Date: 31 March 2016

RE: RMS Comments, DA 15/198, 2-18 Rosenthal Avenue
Proposed Car Park Redevelopment

Draft Construction **and** **Traffic Management Plan**

Figure 1 – Rosenthal Avenue Car Park Total Hourly Trip Generation

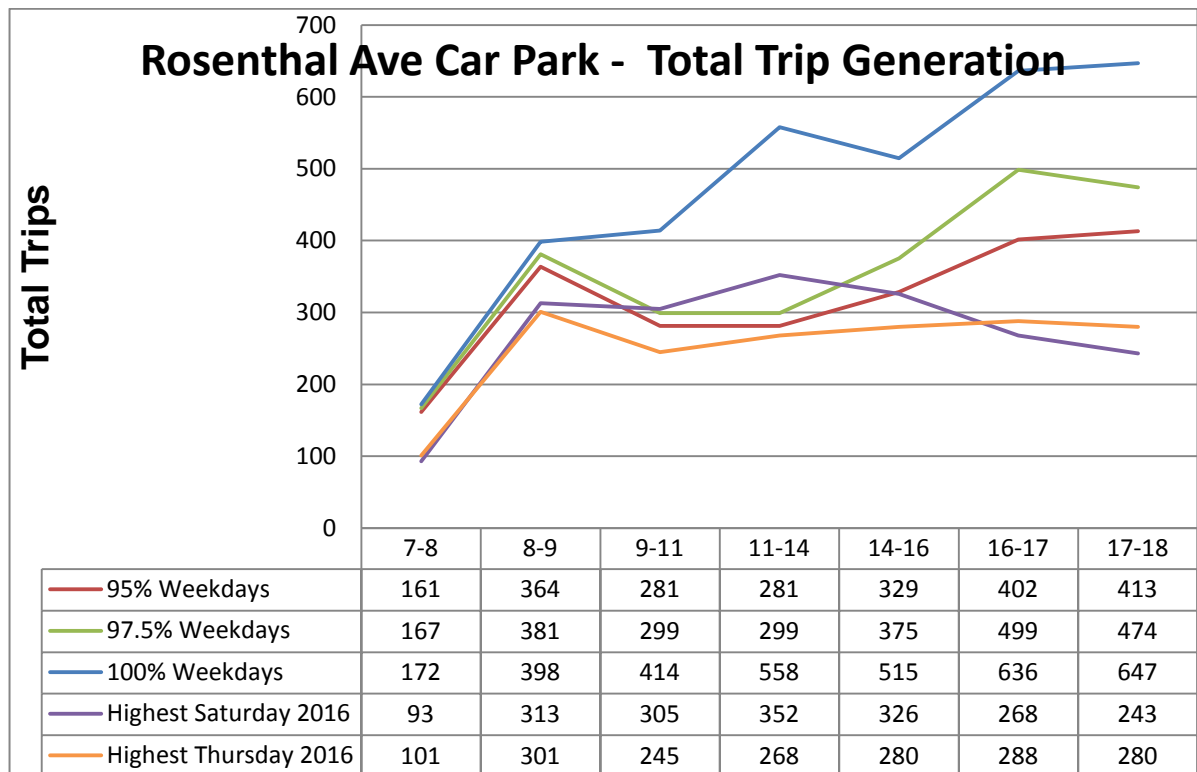
2. In Section 3.6.5 the peak traffic generation from the proposed redevelopment has been estimated based on 95% highest traffic reported peak hour trip generation at 402 trips, but 100% highest peak hour traffic generation in the PM peak is 636 trips. Therefore, the proposed roundabout intersection should be modelled based on 'worse case' scenario of 1237 trips rather than 1003 trips.

A further review of the usage of the Rosenthal Avenue Car Park post the opening of the Little Street Car Park has been undertaken for Thursdays and Saturdays over a 7 week period commencing 4 and 6 February 2016 respectively. The results have been added to the graph previously provided as Figure 1 in the Traffic Report as set out in Figure 1 below.

It can then be seen that whilst the highest trip generation for a Thursday during this 7 week period is generally consistent with, albeit slightly lower than the 95%

assessment range of all trips used in the data used to produce Figure 1 in the Traffic Report.

It can also be seen that the highest trip generation for a Saturday morning during this 7 week period is generally consistent with, albeit slightly higher than the 95% assessment range of all trips used in the data used to produce Figure 1 in the Traffic Report for weekday usage.

This additional review of POD's data confirms that it is appropriate to base the trip generation on 95% of data recorded from POD's in the existing Rosenthal Avenue car park.

That Council and RMS accept that the 95% highest traffic reported peak hour trip generation is an appropriate indicator of the typical peak hour trip generation of the existing car park.
